NOTE TO: FILE  
LICENSEE: Mississippi Power & Light  
FACILITY: Grand Gulf Unit 1  
SUBJECT: INFORMATION GIVEN TO MISSISSIPPI POWER AND LIGHT COMPANY  
REGARDING THE GRAND GULF TECHNICAL SPECIFICATION REVIEW

# Technical Specifications

Grand Gulf Nuclear Station,

*Marked-up by  
NRR/SSPB and provided  
to MP&L in  
Meetings during May  
& June 1984*

Figure 3.4.6.1-1

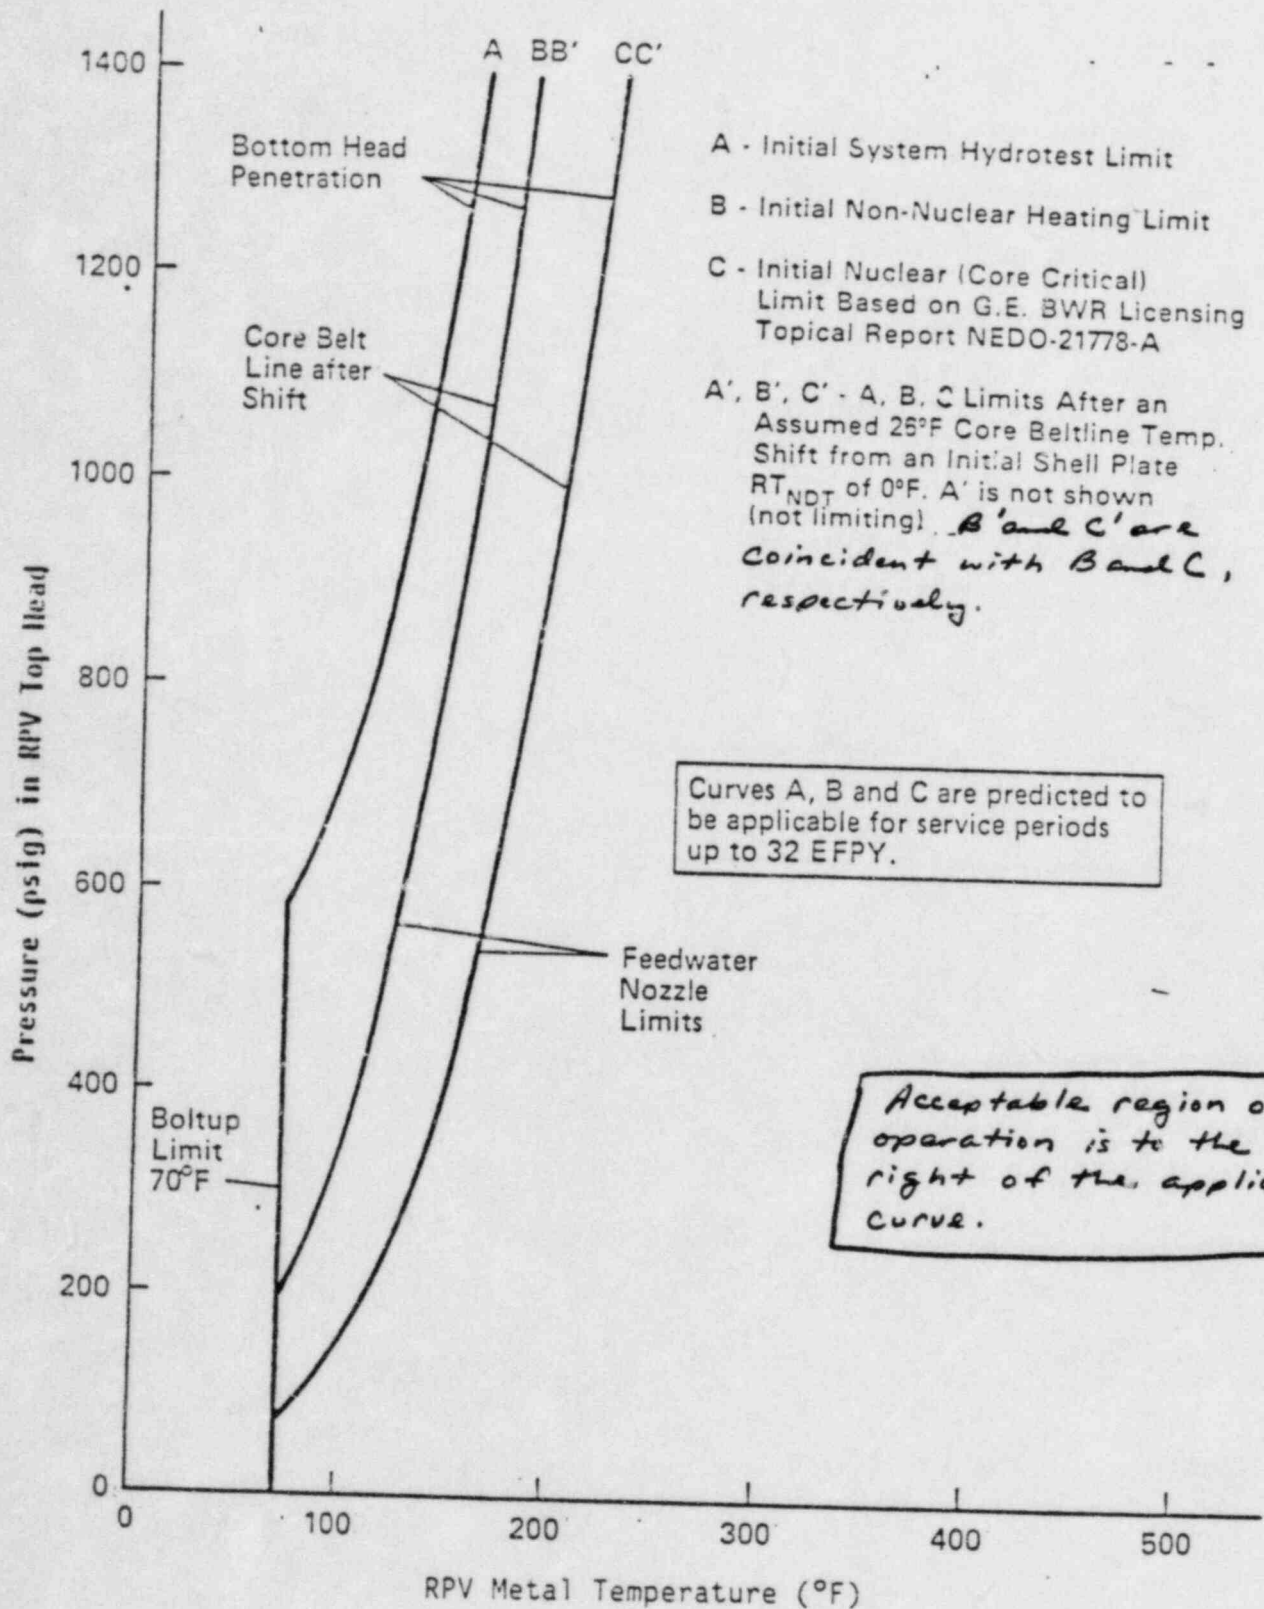
3.4.6.1 The reactor coolant system ~~temperature and~~ <sup>and reactor vessel metal temperature</sup> pressure shall be limited in accordance with the limit lines shown on Figure 3.4.6.1-1 (1) curve A for hydrostatic or leak testing; (2) curve B for heatup by non-nuclear means, cooldown following a nuclear shutdown and low power PHYSICS TESTS; and (3) curve C for operations with a critical core other than low power PHYSICS TESTS, with:

4.4.6.1.1 During system heatup, cooldown and inservice leak and hydrostatic testing operations, the reactor coolant system ~~temperature and pressure~~ shall be determined to be within the above required heatup and cooldown limits and to the right of the limit lines of Figure 3.4.6.1-1 curves A or ~~B~~, as applicable, at least once per 30 minutes.

4.4.6.1.2 The reactor coolant system ~~temperature and pressure~~ shall be determined to be to the right of the criticality limit line of Figure 3.4.6.1-1 curves C and C' within 15 minutes prior to the withdrawal of control rods to bring the reactor to criticality and at least once per 30 minutes during system heatup.

Figure B 3/4 2.3-1

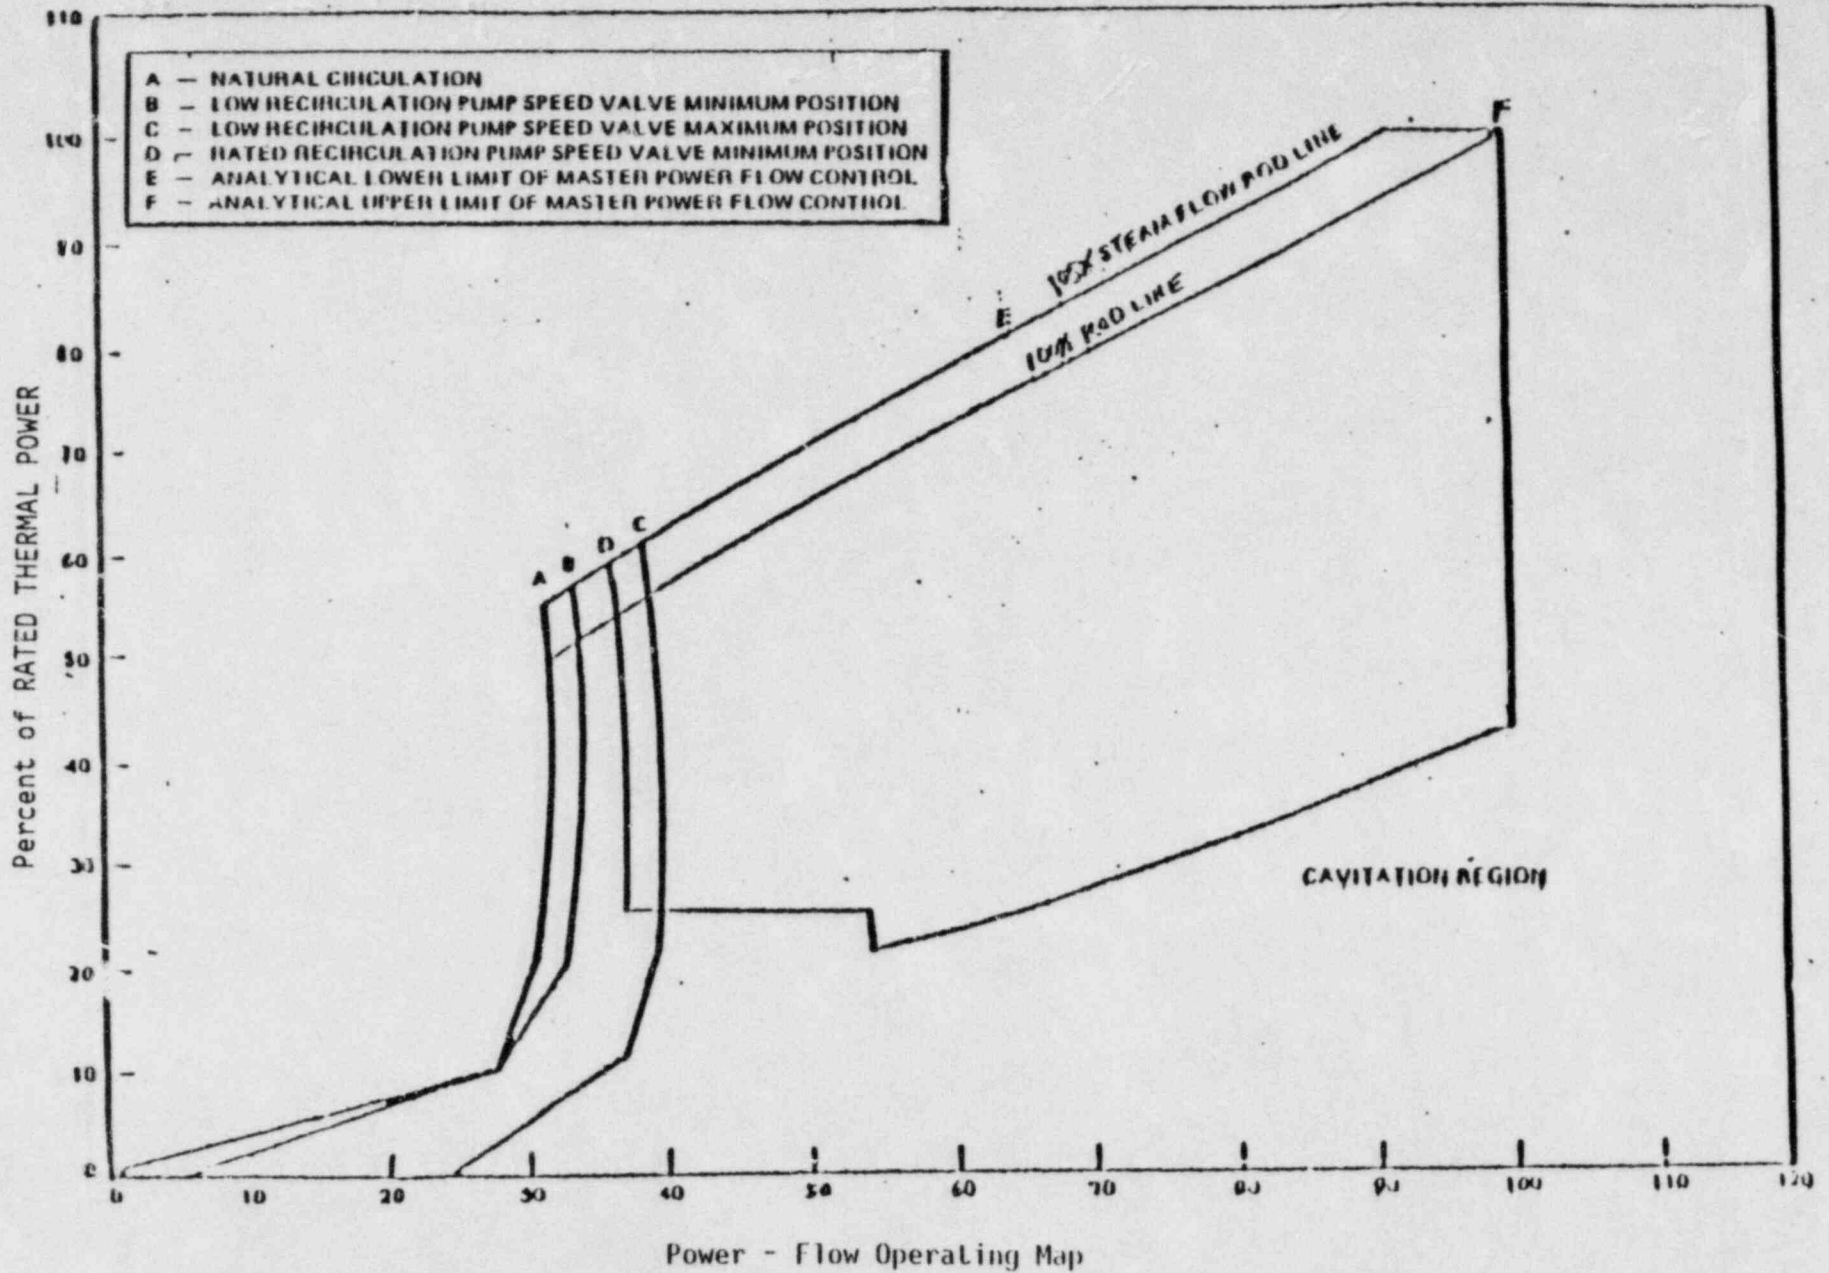
INSERT
